## GNSS Manufacturing Site Change Notice

| <b>DATE ISSUED:</b>         | 15 <sup>th</sup> Jan, 2018                                                                                                                                                                                                                                                                                                                                                              | <b>TRACKING NUMBER:</b> | 41112038 |
| <b>BULLETIN:</b>            | GNSS modules change of manufacturing site and associated changes                                                                                                                                                                                                                                                                                                                        |                         |          |

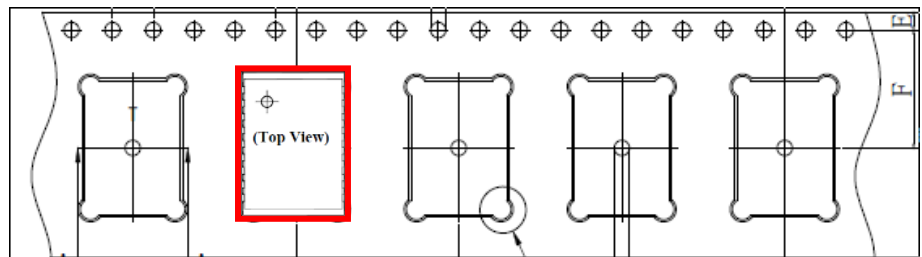
New Sierra standard packaging will be used for all GNSS modules shipped from the new site. Details given below:
